## REVISED RESPONSE TO REQUEST FOR ADDITIONAL INFORMATION

### APR1400 Design Certification

Docket No. 52-046

RAI No.: 227-8274  
SRP Section: 03.08.04 – Other Seismic Category I Structures  
Application Section: SRP 3.8.4  
Date of RAI Issue: 09/25/2015

Figure 1 Static Lateral Pressure

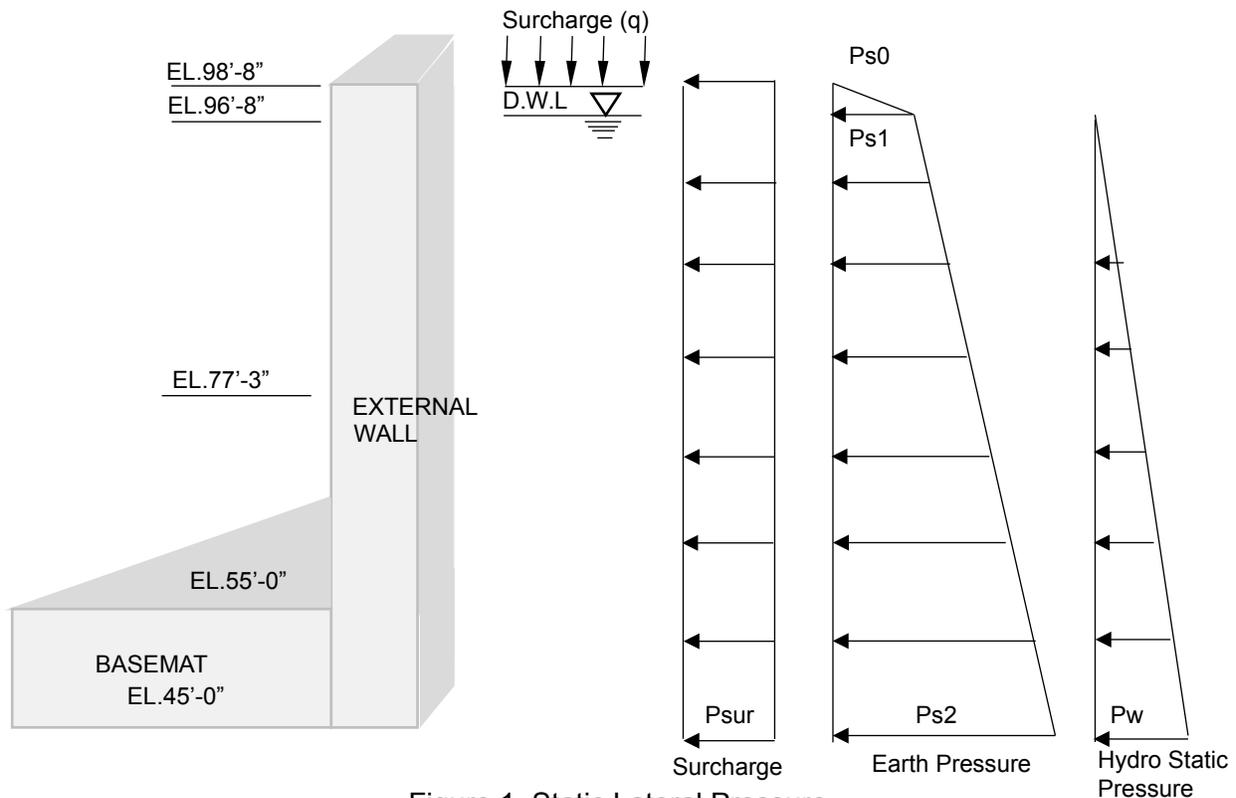
Applicant is requested to describe how the various water/flood related loads are classified (e.g., normal, severe environmental, abnormal, etc.), how they are calculated in terms of the loads used in DCD Section 3.8.4, how are they applied in the design of seismic Category I structures,

Hydrostatic loads are calculated as a linearly distributed pressure on external walls depending on the design water level (EL. 96'-8") according to the basic equation of hydrostatics as shown in Figure 1. [The design groundwater elevation for the APR1400 standard plant design is based on the EPRI ALWR URD \(Utility Requirement Document\) Table 1.2-6 "Envelope of ALWR Plant Site Design Parameter".](#) Therefore, the maximum design ground water level is determined to be 0.61m (2 feet) below the plant grade in the vicinity of the SSSc important to safety. Please see the applicant's response to RAI 75-8023 Question No. 03.04.02-1 item a.(ii).
